# UNITED STATES PATENT AND TRADEMARK OFFICE

APPLICATION NO.	FILING DATE	FIRST NAMED INVENTOR	ATTORNEY DOCKET NO.	CONFIRMATION NO.
10/509,748	09/30/2004	Terumasa Ide	43890-692	4389

<b>Office Action Summary</b>	<b>Application No.</b> 10/509,748	<b>Applicant(s)</b> IDE ET AL.	
	<b>Examiner</b> ALEXANDER B. COMLEY	<b>Art Unit</b> 3746

## **DETAILED ACTION**

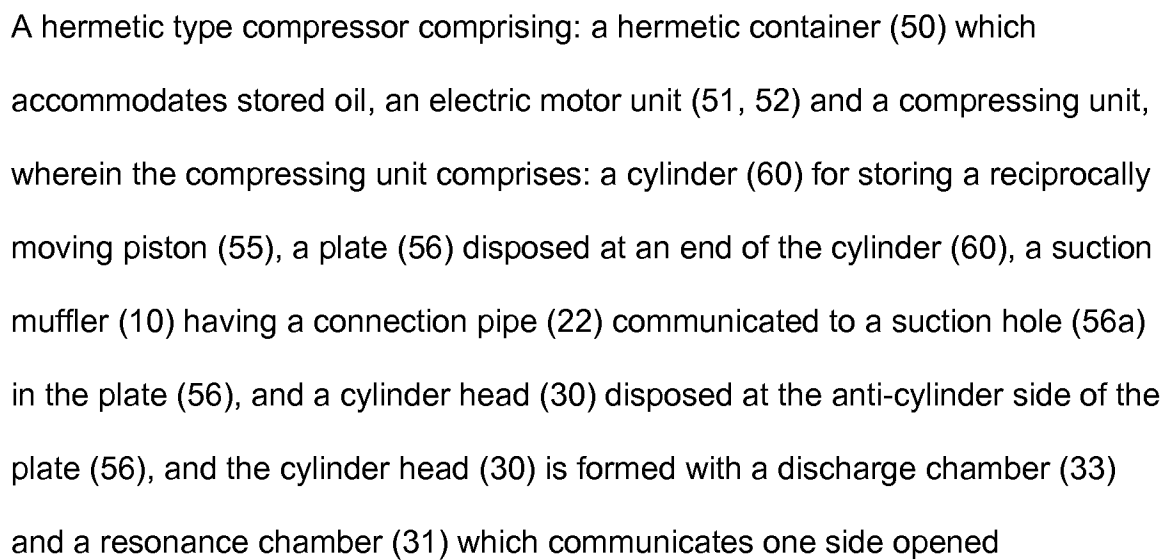
4. **Claims 1 & 6-7** are rejected under 35 U.S.C. 102(b) as being anticipated by United States Patent to Lee (5,542,824) directed to a Refrigerant Compressor Having Interconnected Muffler Section.

connection pipe (22); a flange (233) of which shape is generally U-shaped having upper and lower surfaces and an outer periphery is disposed at an outer periphery of the connection pipe (22); the cylinder head (30) is provided with a generally U-shaped groove (234) to which the generally U-shaped flange (233) is fitted at a position corresponding to the flange (233); and by fitting the flange (233) into the groove (234), having an effective sealing width added to the upper and lower surfaces and the outer surface, thereby forming a seal portion so as to prevent a leakage of pressure pulsation in the resonance chamber (31) to the outside.

As shown in Figures 3 and 4 above, Lee discloses a hermetic compressor unit that utilizes a specially-designed suction muffler attachment structure designed to affix the muffler to the cylinder head using flange-and-groove connection means (See Fig. 4). In particular, Lee discloses "A pair of protruding ears 233 form nut fixing grooves 234 and are received by the concave grooves 32 formed at the sides of the suction chamber 31 in the cylinder head 30. The ears are fastened to holes 32a formed in the concave grooves 32 by fastening members 239." (Column 5, Lines 27-31) Therefore, it is clear that Lee's suction muffler is attached using U-shaped flanges placed within corresponding U-shaped grooves, and consequently, would provide improved sealing specifically at the resonance chamber interface.

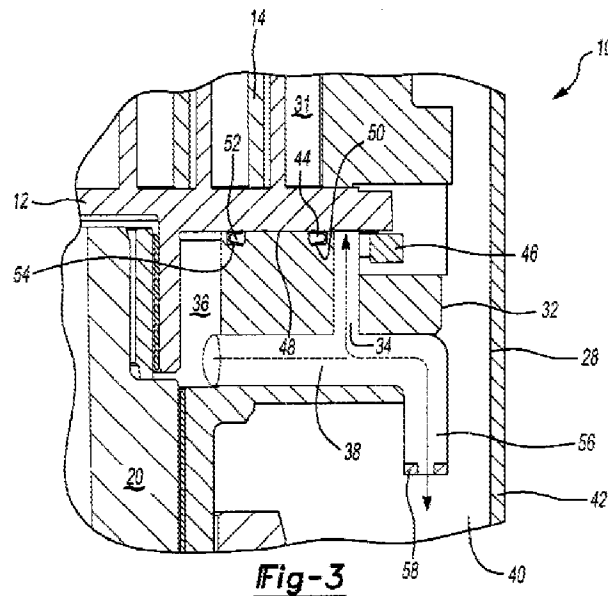
8. **Claims 4-5** are rejected under 35 U.S.C. 103(a) as being unpatentable over United States Patent to Lee (5,542,824) directed to a Refrigerant Compressor Having Interconnected Muffler Section in view of United States Patent to Fenocchi et al. (6,464,480) directed to an Oil Spout for a Scroll Compressor.

Lee does not disclose an oil hole disposed at the bottom of the suction muffler specifically for allowing oil to lubricate the seal portion (although Lee does disclose an oil hole located at the bottom of the suction muffler). However, Fenocchi specifically discloses, in Figure 3 seen above, a compressor having an oil spout 34 that redirects a portion of oil entering an oil return passage 38 to supply lubrication between an outer seal 44 and a coupling 46. Fenocchi's setup provides enhanced seal reliability, as made clear by Fenocchi stating "The oil spout provides a continual flow of lubrication to the outer seal and the coupling, preventing excessive wear of the outer seal and improving seal reliability" (Column 1, Lines 54-56). Therefore, to one of ordinary skill desiring enhanced seal life through lubrication, it would have been obvious to utilize the techniques disclosed in Lee in combination with those seen in Fenocchi in order to obtain such a result. Consequently, it would have been obvious to one of ordinary skill in the art at the time of the invention to modify the suction muffler and suction base of Lee with an oil hole similar to that of Fenocchi in order to obtain predictable results;

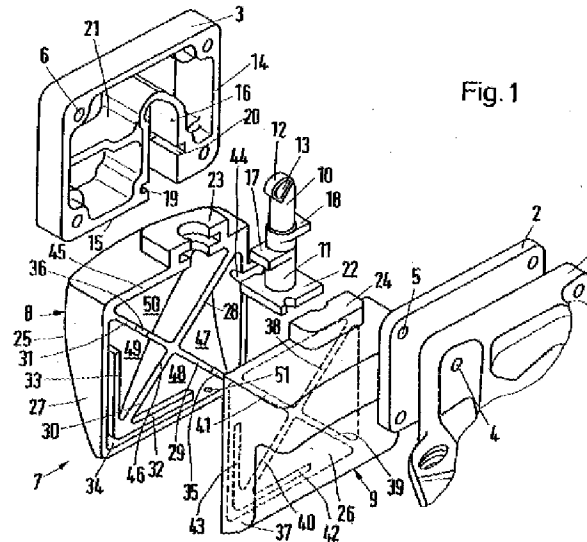
9. **Claims 8 & 10** are rejected under 35 U.S.C. 103(a) as being unpatentable over United States Patent to Lee (5,542,824) directed to a Refrigerant Compressor Having Interconnected Muffler Section in view of United States Patent to Outzen (4,759,693) directed to a Suction Sound Damper

Lee does not specifically disclose that the resonance frequency of the suction muffler opening is coincident with the resonance frequency of a resonance muffler. However, Outzen discloses the use of appropriately selected resonance frequencies when and if less noise is desired. In particular, Outzen discloses a suction sound damper designed to eliminate resonance oscillations altogether by stating "It is particularly favourable for the shells to be substantially rectangular...Such a suction sound damper can be accommodated in the capsule to save space and has an

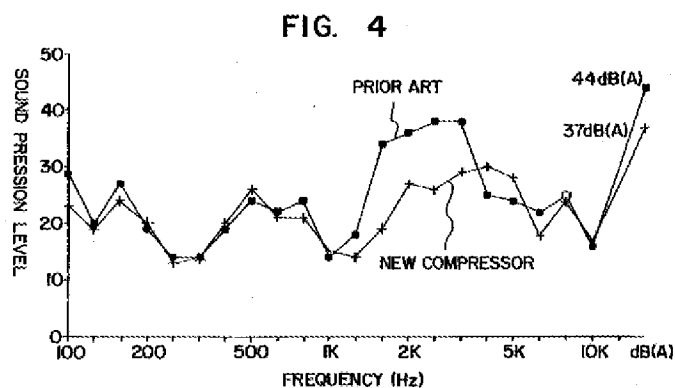
10. **Claims 9** is rejected under 35 U.S.C. 103(a) as being unpatentable over United States Patent to Lee (5,542,824) directed to a Refrigerant Compressor Having Interconnected Muffler Section in view of United States Patent to Alfano et al. (5,487,648) directed to a Shell Configuration for a Hermetic Compressor.

Lee does not disclose that the resonance frequency of a plane portion of the hermetic container and the resonance frequency of the opening of the suction muffler are independent of each other. However, Alfano et al. specifically discloses the particular method of designing the container to have a resonance frequency different than that of motor compressor itself. In particular, Alfano states, "In the hermetic motor compressors for home refrigerators, beside the efficiency, a very important issue is the noise produced by the motor compressor and transmitted outside by the shell. It is known that for reducing the noise it is necessary to shape the shell in such a way that its resonance frequency is different from the frequency of the motor compressor." (Column 1, Lines 23-29) Therefore, since the suction muffler together with the motor may form the "motor compressor", Alfano et al. makes it obvious to vary the frequencies of the hermetic container and the suction muffler. Therefore, to one of ordinary skill desiring a quieter compressor unit, it would have been obvious to utilize the techniques disclosed in Lee in combination with those seen in Alfano in order to obtain such a result. Consequently, it would have been obvious to one of ordinary skill in the art at the time of the invention to modify the compressor structure of Lee with the differing resonant frequencies of Alfano et al. in order to obtain predictable results; those results being a much quieter compressor that eliminates much of the audible annoyances associated with comparable compressors.
